## **HERITAGE VAUGHAN COMMITTEE AUGUST 21, 2013**

### **1. 1 CLADDAMOUR PLACE – PROPOSED CHANGE TO APPROVED DESIGN FOR PROPOSED NEW CONSTRUCTION – WARD 2**

Approved July 17, 2013: North Elevation (facing Claddamour) - \* all materials will require review of samples for approval

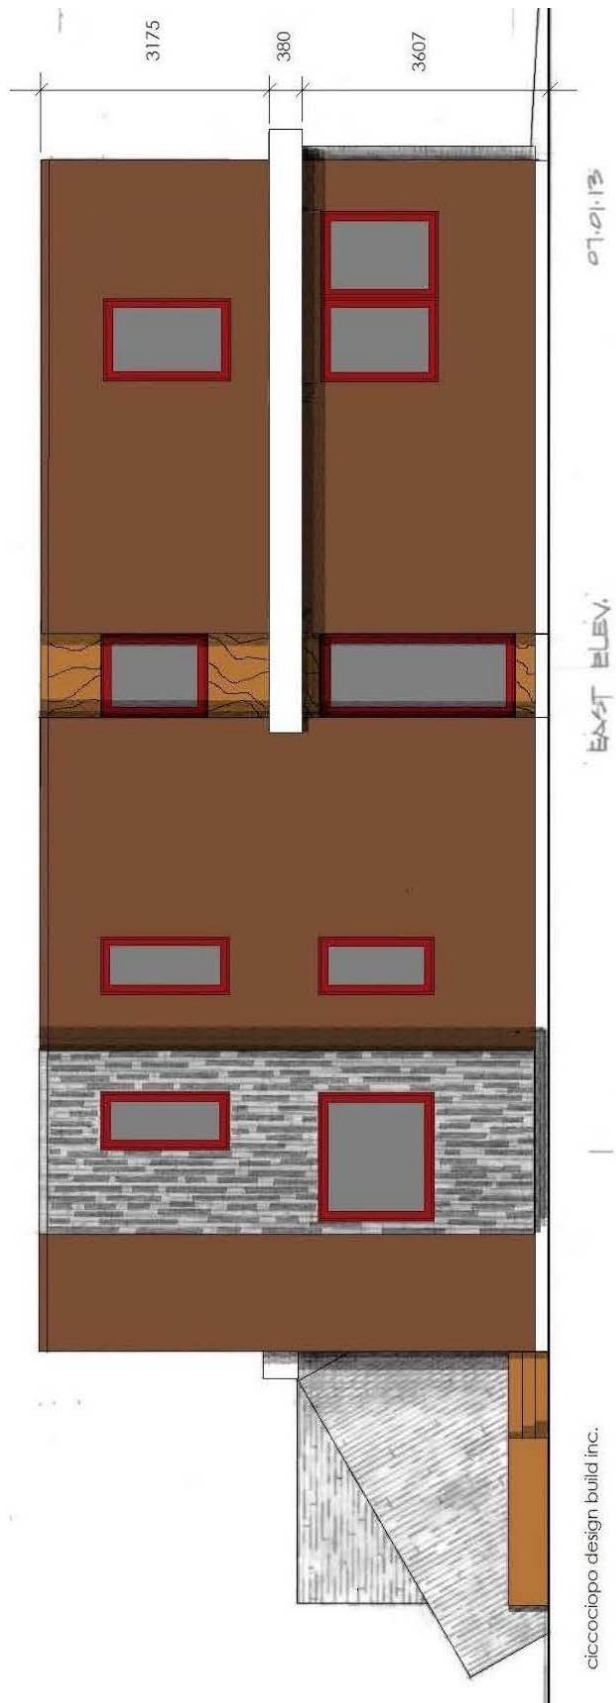
The block on the left and the block on the right are discernible and are consistent with the rationale for the design in plan shown in the site plan. The form of the link portion on the second floor is clearly discernible in form and distinct cladding material that has been assigned to it (two blocks fused together). The link would be flush at roof with the adjacent blocks. The module represented in the single rectangular window pane follows a close proportion to a traditional 1 to 2 vertical proportion. This module idea, sometimes adjusted to fit within other important compositional lines, is used to make the different window compositions. Using a vertical window proportion connects with the traditional notion of a window. Having the punched windows on the elevation is a direct reference to traditional architecture in the area. Adding wood paneling between them blurs this significant reference to the contributing context. The aim of the guidelines in terms of contemporary design is to make the design contributing with obvious references to traditional building in the composition.

Based on the analysis, staff finds that the design as approved in the July meeting is consistent in the main narrative as described above and shows sufficient references to the contributing context of the Clarence Street Character area. The proposed design provides a strong clear link to the traditional punched windows in traditional buildings on the east block of the design, while being very clearly consistent with the narrative of the distinct link and two blocks. The approved design has the clearest reference to the context while still maintaining a contemporary interpretation and consistency with the narrative of the middle link and blocks, connection to the natural environment of the character area through the punched windows, material palette, reference to traditional palette in the brick size, wood palette, stone and colour of window frames, with the extended wrap around "canopy line" in reference to traditional wraparound porches. The idea discussed here was to make it look like a seamless fascia line.

1. That Heritage Vaughan not support the proposed revisions to the proposed design for 1 Claddamour Place, Woodbridge.

Approved July 17, 2013: East Elevation (facing Clarence Street)

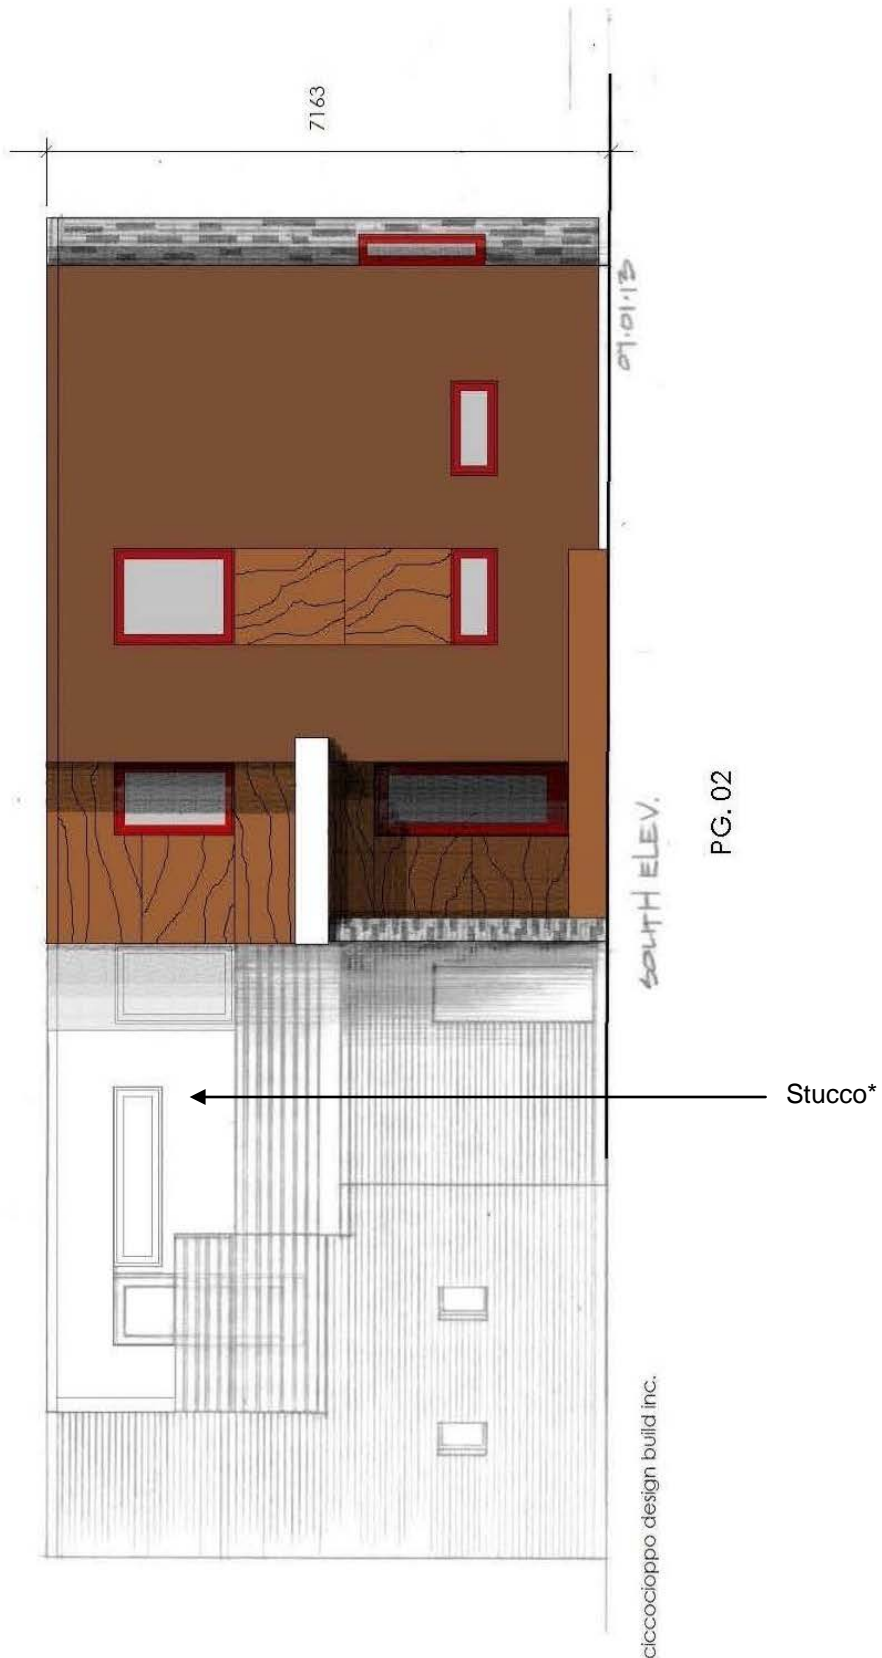
The applicant has since has requested that a change in the elevation incorporating wood panels between the two windows on the second floor of the east block on the Claddamour elevation.

The applicant has presented this option, a variation of the concept approved in the July meeting composition which shows additional wood paneling on the Claddamour façade and Clarence Street, filling in the gap between the windows on the upper floor, East block. The applicant has indicated that the paneling differentiates the East block containing quarters to the west, containing the more utilitarian section of the house. The rest of the elevations would be as previously approved. *Please also refer to the attachments in this report.*
